ECE/TRANS/WP.29/GRE/2006/35
21 July 2006

World Forum for Harmonization of Vehicle Regulations (WP.29)

PROPOSAL FOR DRAFT SUPPLEMENT 29 TO THE 03 SERIES OF AMENDMENTS TO
REGULATION No. 37

(Filament lamps)

Insert new sheets H15/1 to 5, between sheet H14/4 and sheet H6W/1, to read:
(see next pages).

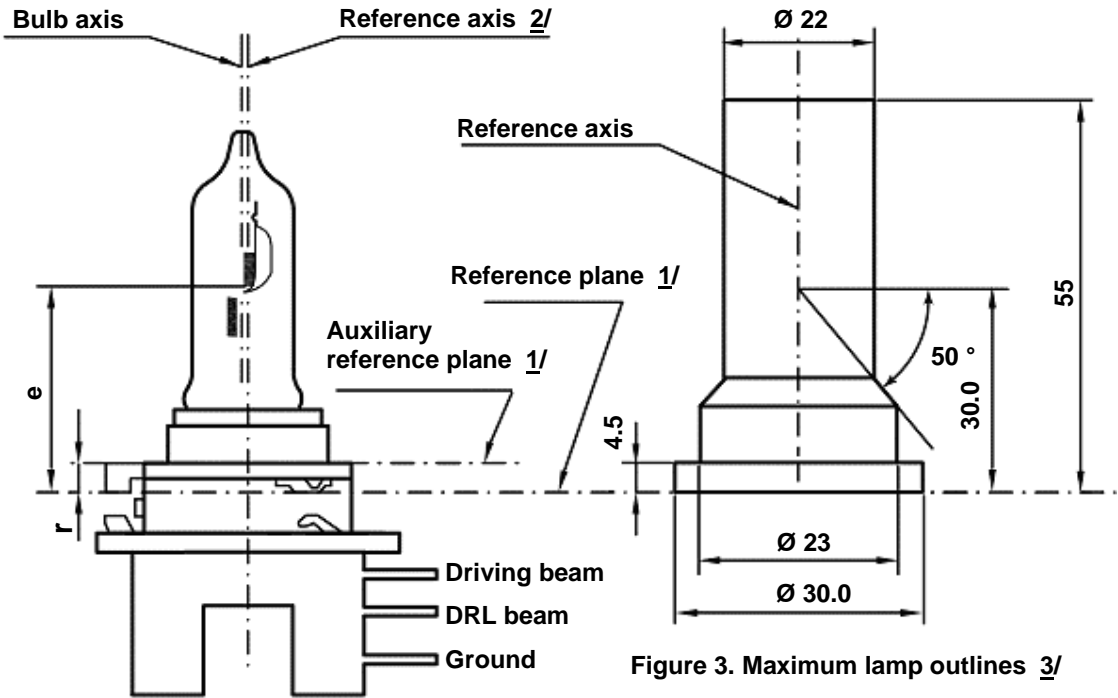
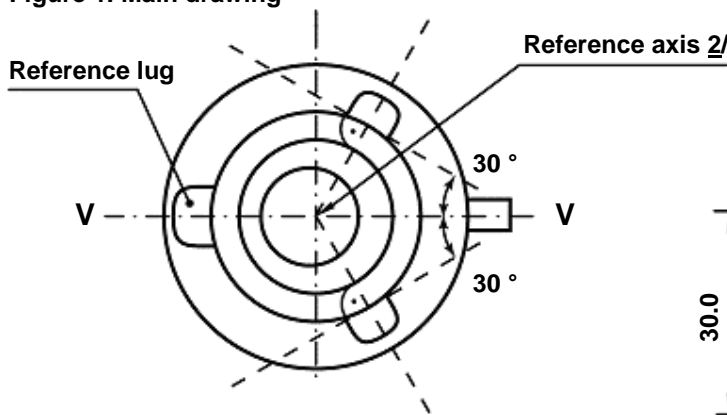
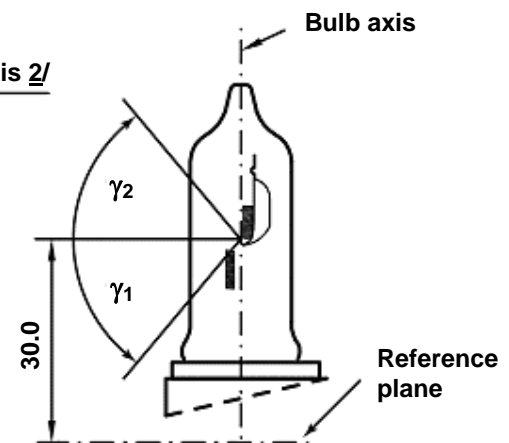
Having in mind the necessity for technical solutions concerning introduction of a mandatory installation of daytime running lamps (DRL), GTB developed a specification for a new dedicated light source category: H15.

While P13W is a single filament light source specific for DRL, this proposal concerns a dual filament light source category specifically designed for the application in combined DRL/ high beam applications, where the available space at the front of the vehicle may be limited.

- 2/ The reference axis is perpendicular to the reference plane and crosses the intersection of the two perpendiculars as indicated in figure 2 on sheet H15/1.

- 3/ Glass bulb and supports shall not exceed the envelope as indicated in figure 3. The envelope is concentric to the reference axis.
- 4/ Glass bulb shall be optically distortion free within the angles γ_1 and γ_2 as indicated in figure 4. This requirement applies to the whole bulb circumference within the angles γ_1 and γ_2 .
